# ADDENDUM NO. 3

**October 30, 2023**

**Bid Package No. 2 - LOWELL HIGH SCHOOL RENOVATIONS  
AND NEW SPORTS COMPLEX  
Lowell, IN 46356**

DRAWING  
**COMMUNITY BUILDING - FIRST FLOOR LIFE SAFETY PLAN**  
PROJECT  
**LOWELL HIGH SCHOOL - RENOVATIONS & NEW SPORTS COMPLEX**  
© GIBRALTAR DESIGN SHEET

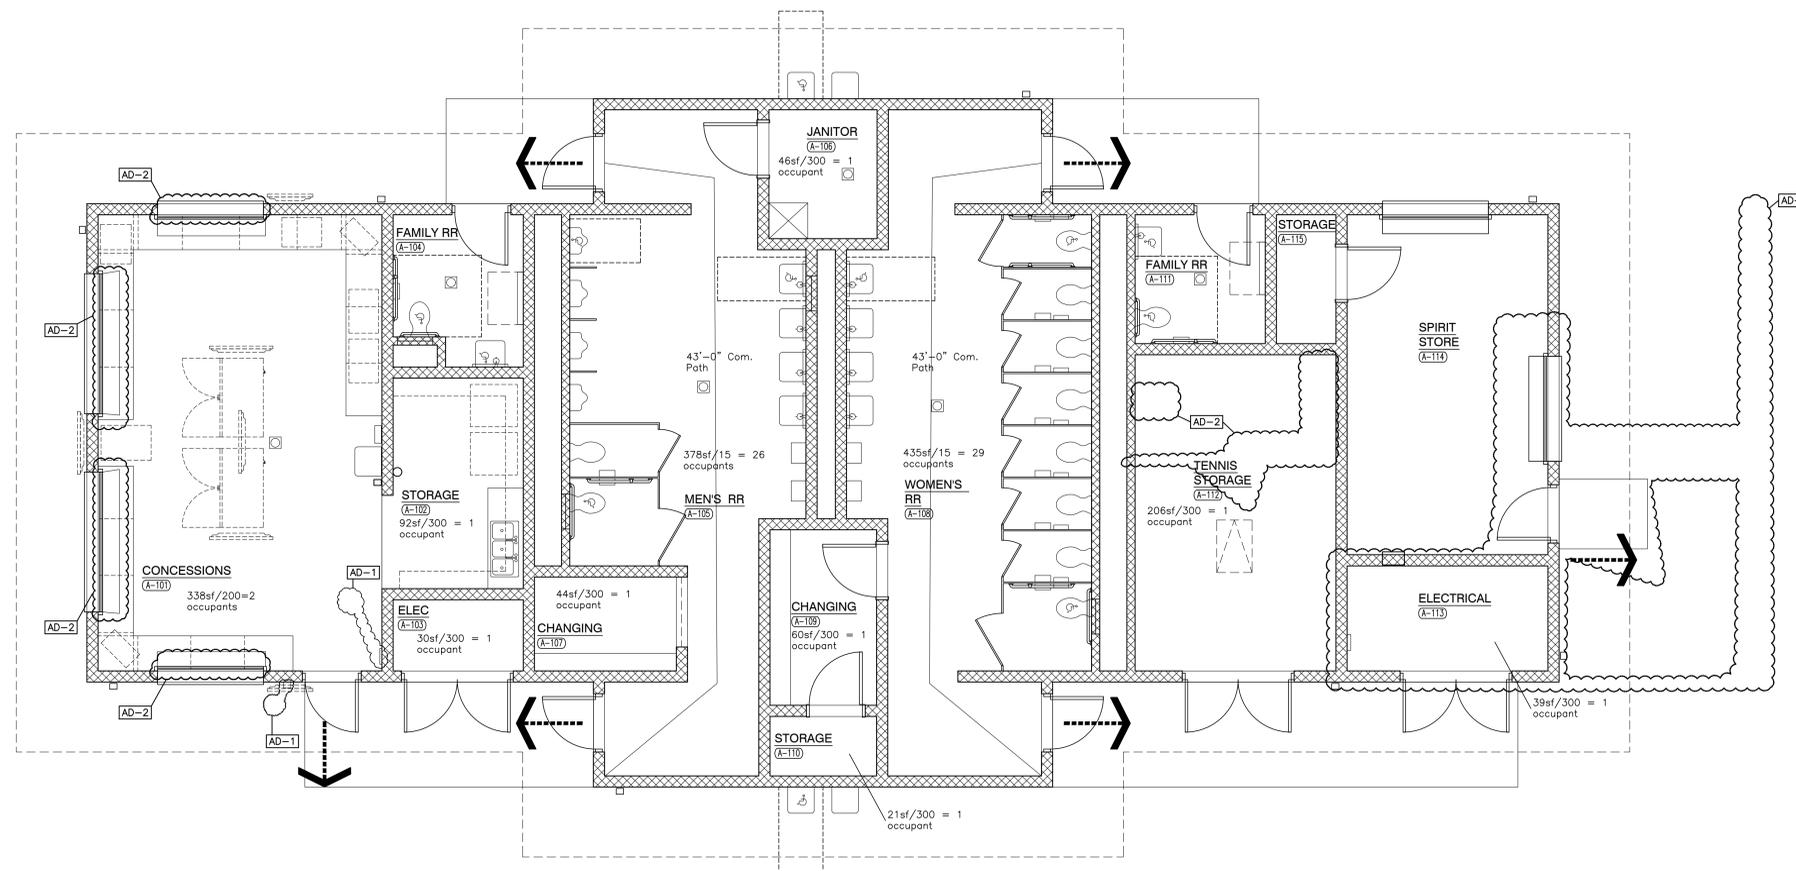
- 1. Sheet G-205-CB**
- A. Refer to revised full size drawing included in this Addendum for the following revisions:
    - 1. Revise code information as indicated.
- 1. Sheet C-2.2**
- A. Clarification: Fence around track is to be 4' H vinyl coated chain link with 4' W single gates and 12' W double gates where drawn on the plan. Refer to C-2.2A and C-2.2B for fence and gate sizes at Tennis, Soccer, Softball, and Baseball.

GIBRALTAR DESIGN SHEET  
**C-2.2A**

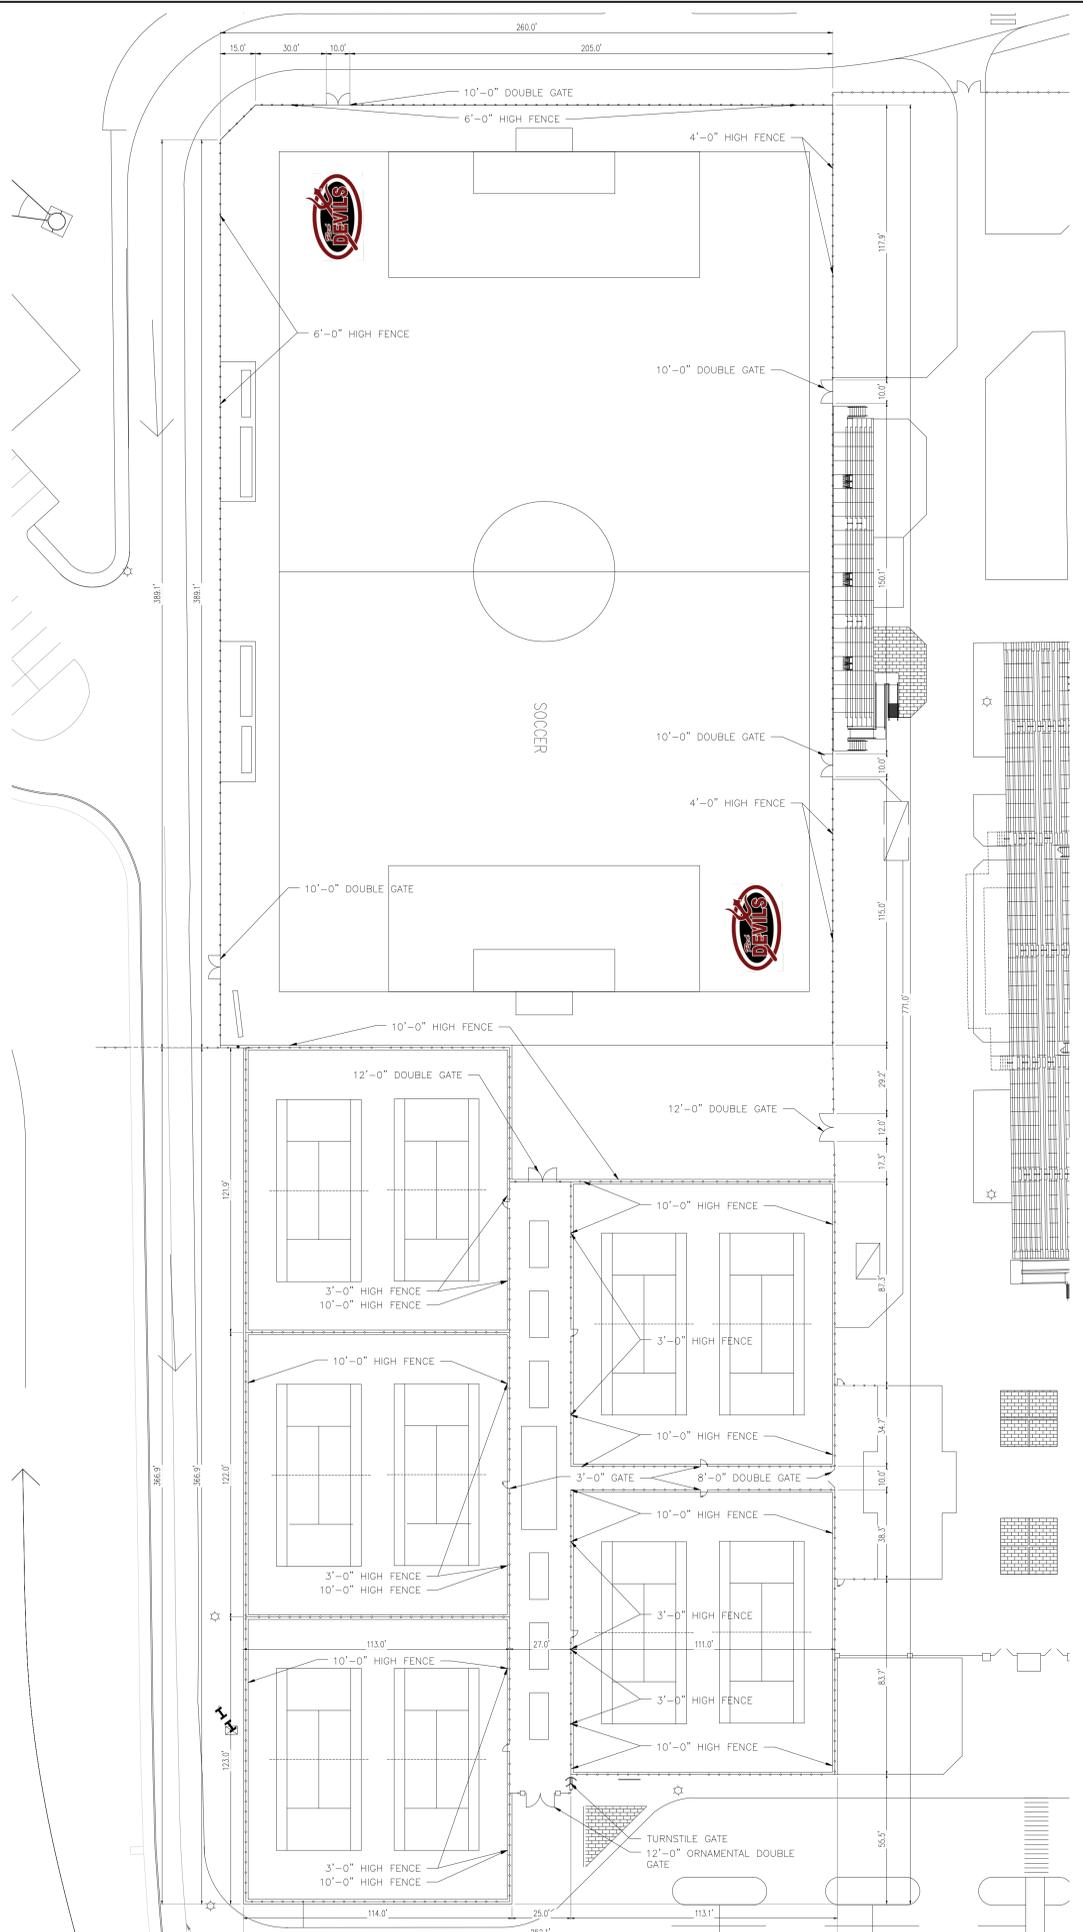
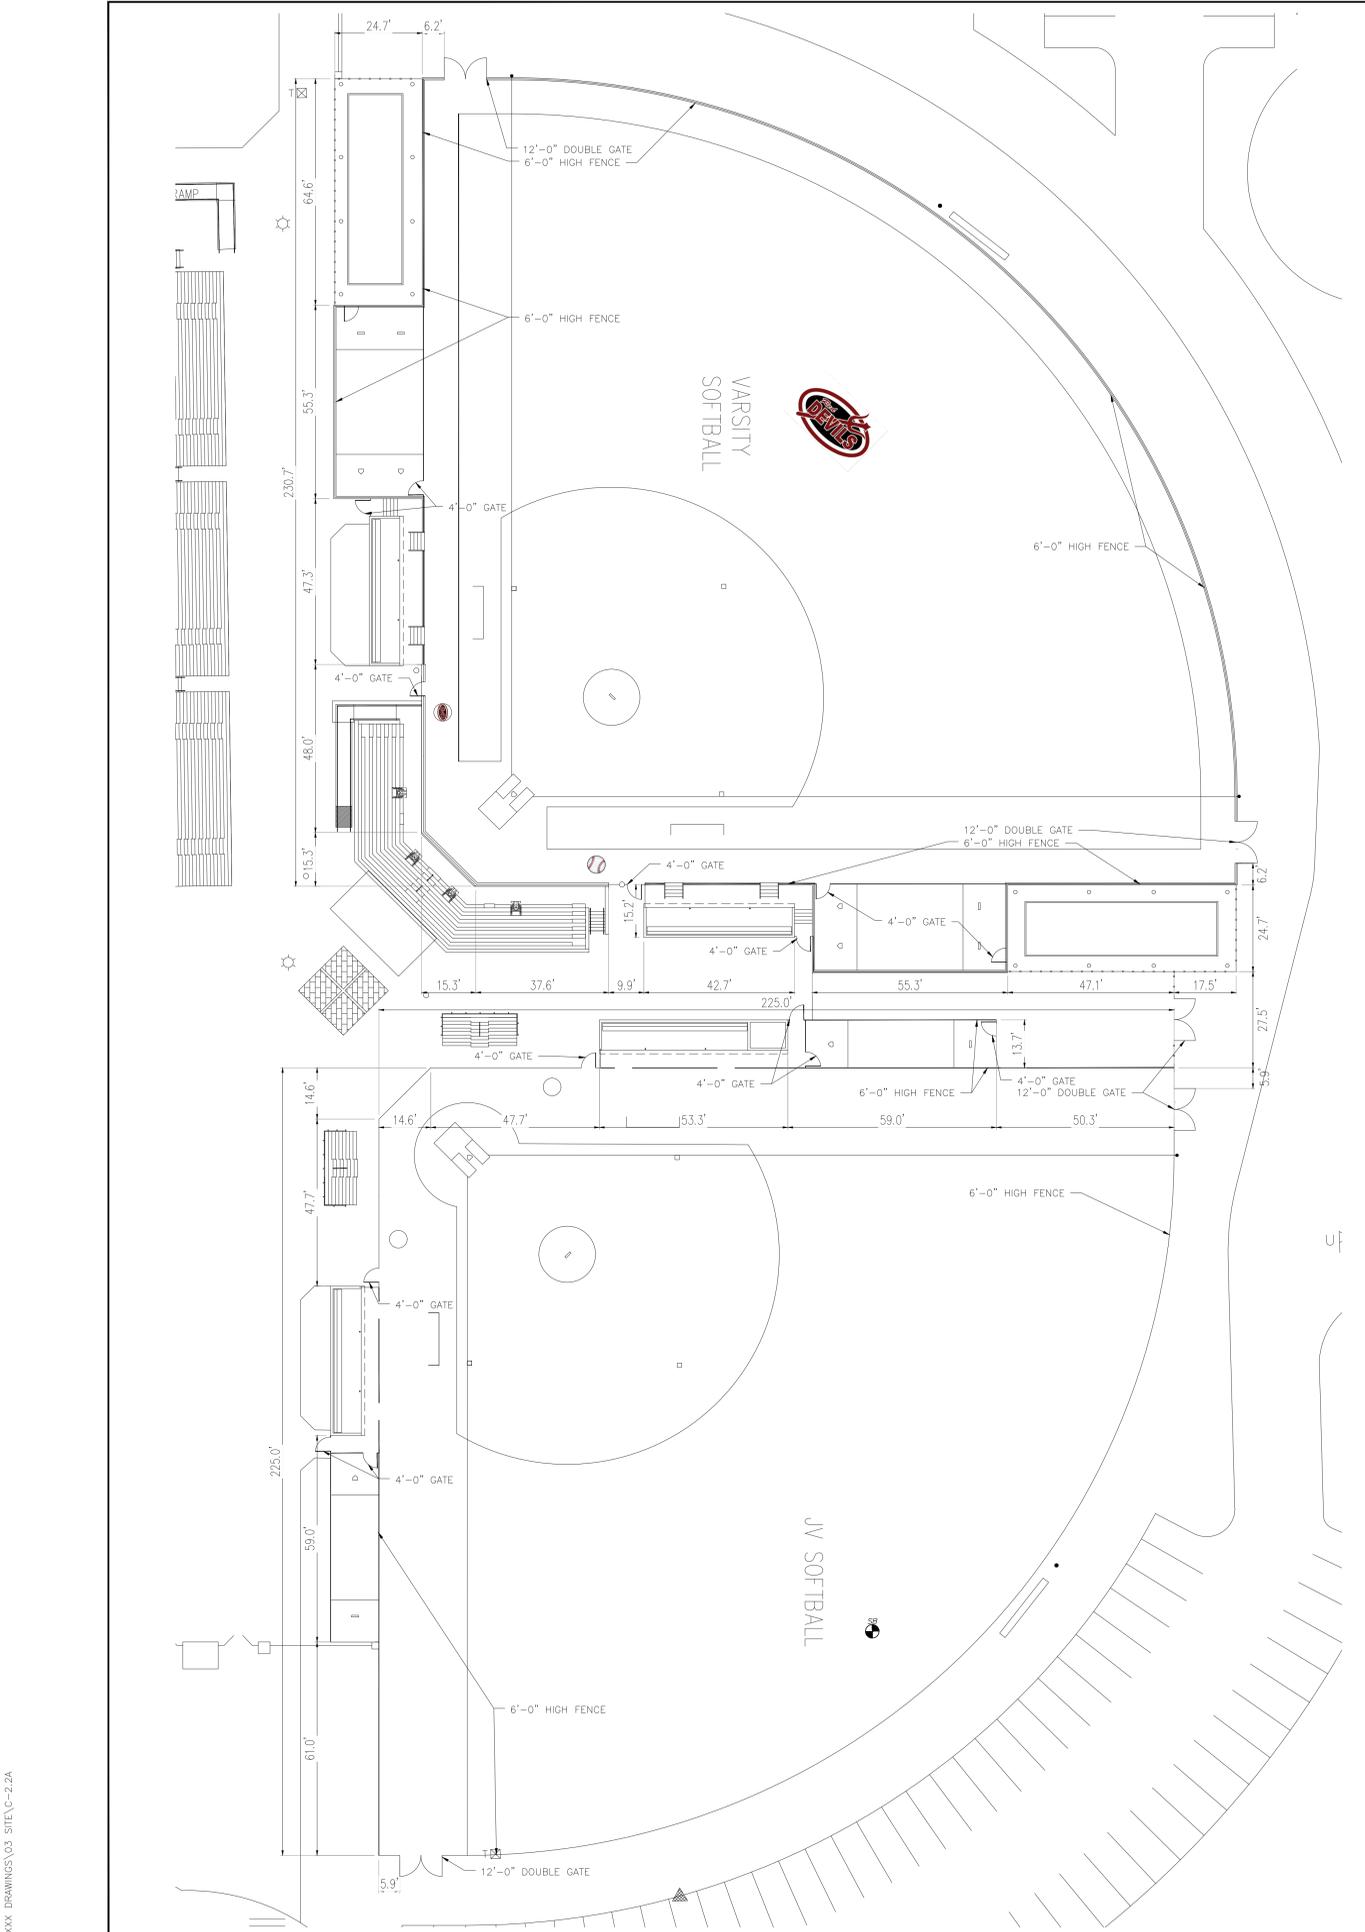
**2. Sheet C-2.2A**

- A. Refer to the new full-size drawing included in this Addendum for supplemental information

GIBRALTAR DESIGN SHEET  
**SB101-SB**

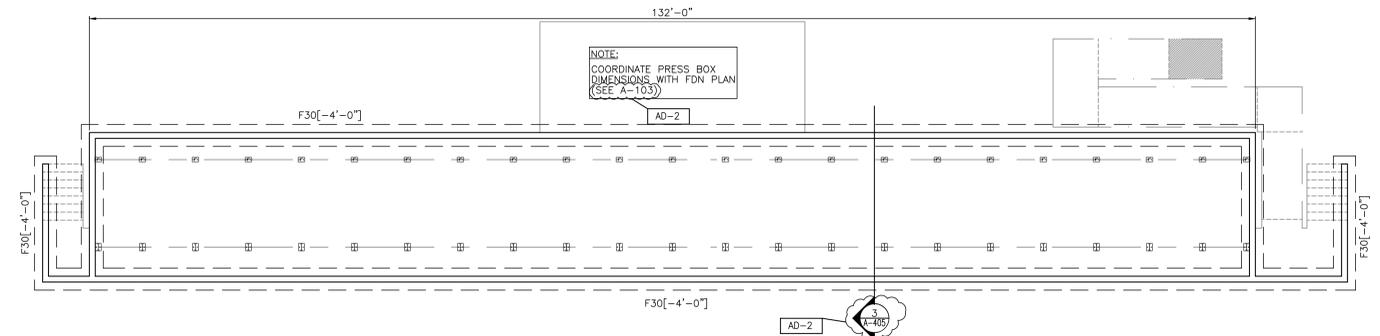
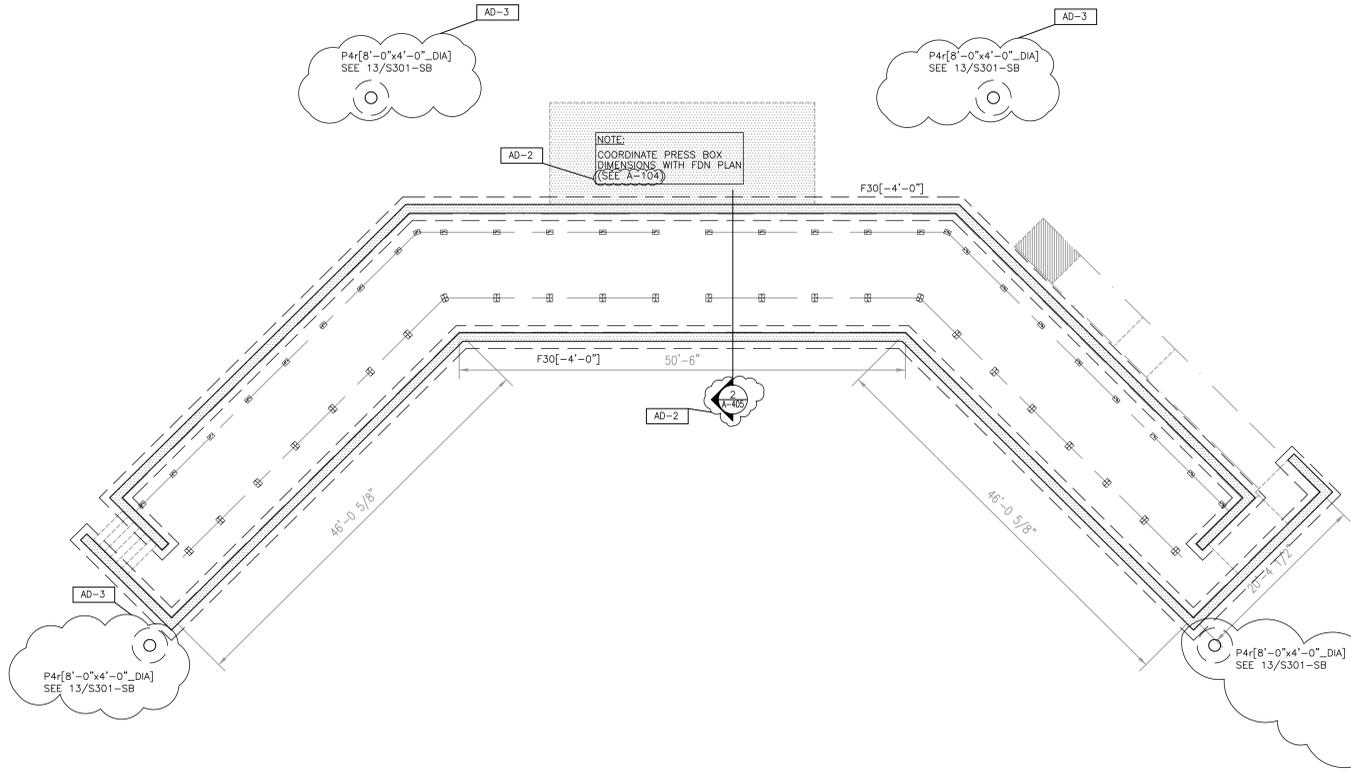
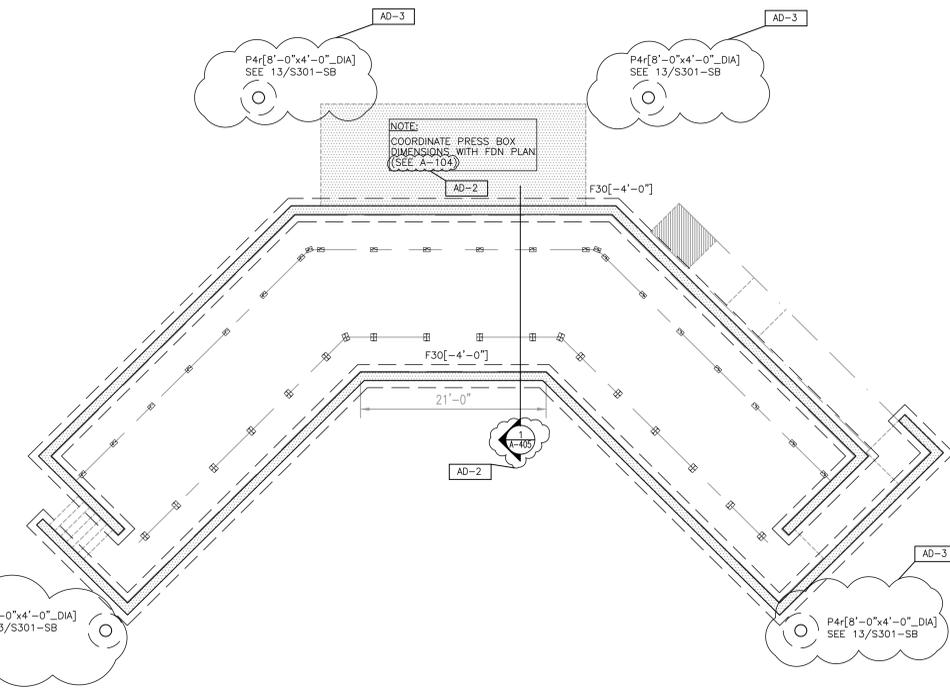
**13. Sheet SB101-SB**

- A. Refer to revised full size drawing included in this Addendum for the following revisions:
1. Add footing for large backstop netting post support information in four locations for "Baseball Grandstand and Foundation Plan" and "Softball Grandstand Foundation Plan".

© GIBRALTAR DESIGN SHEET  
**A-102-SB**

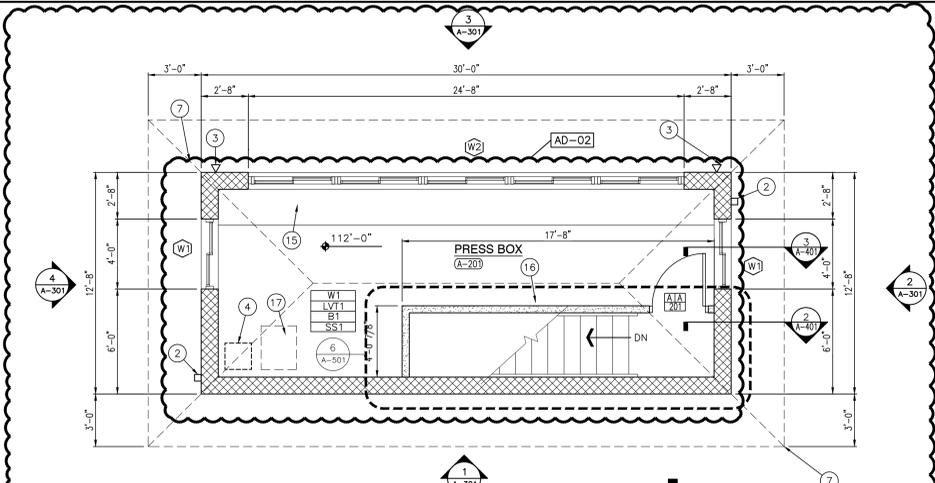
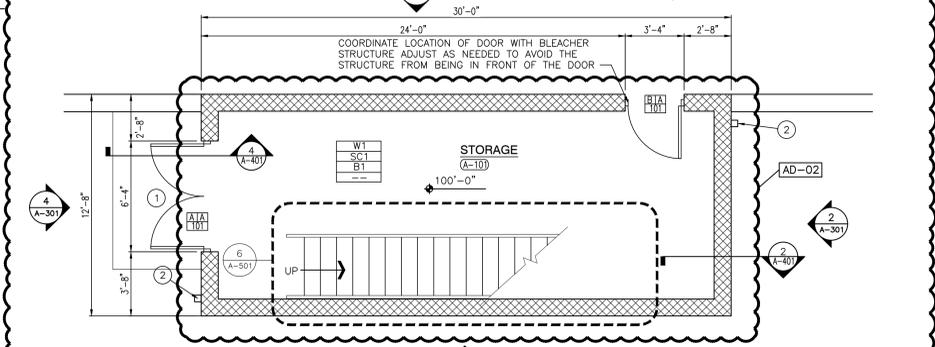
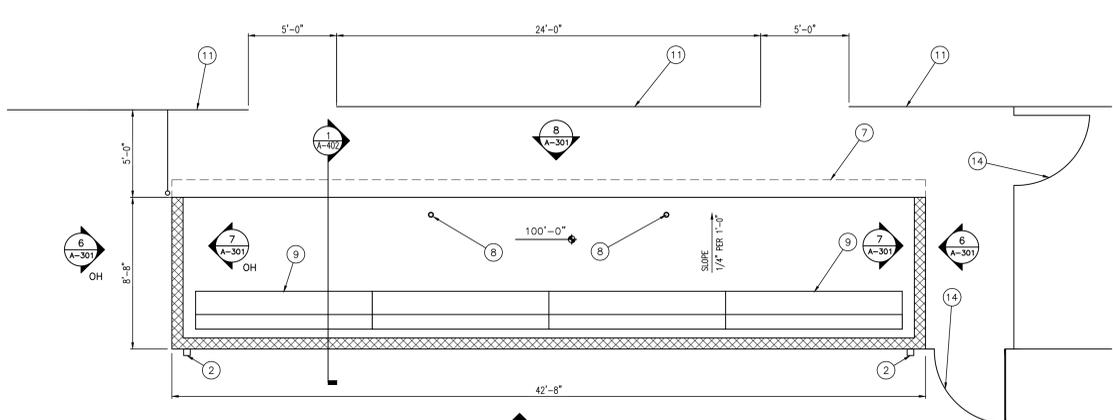
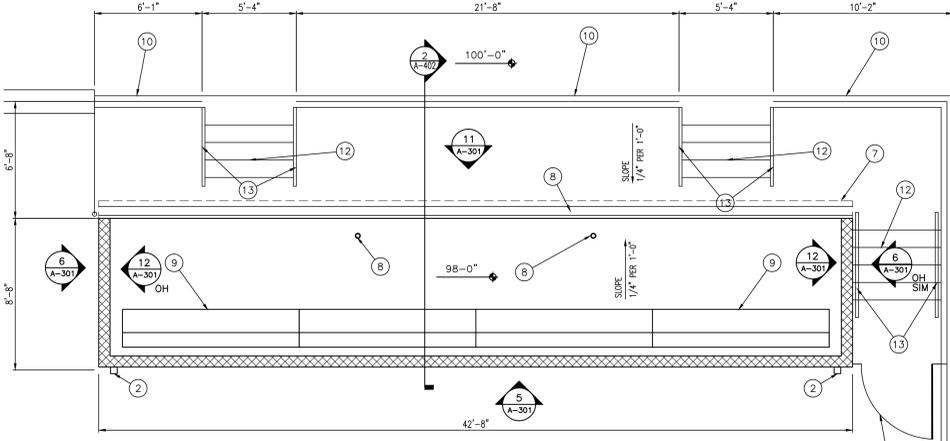
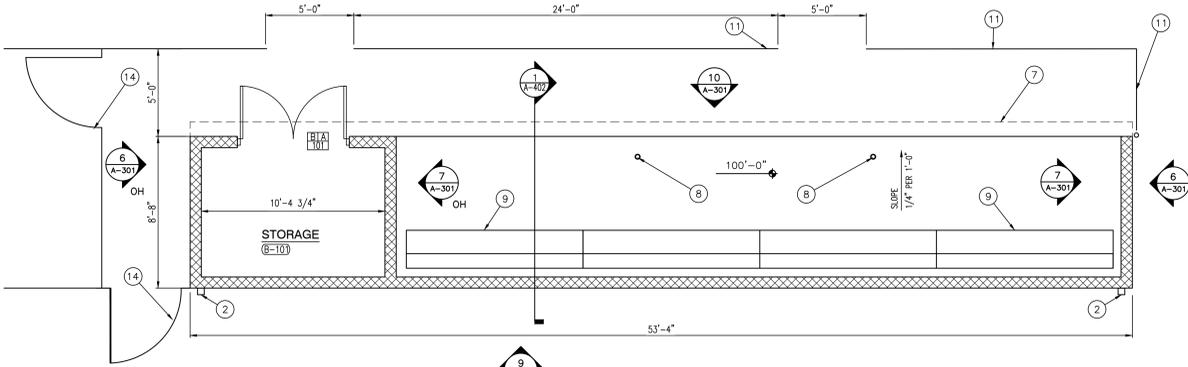
**17. Sheet A-102-SB**

- A. Refer to revised full-size drawing included in this Addendum for the following revisions:
1. Revise General Plan note E.
  2. Revise the large piers at ticket booths.
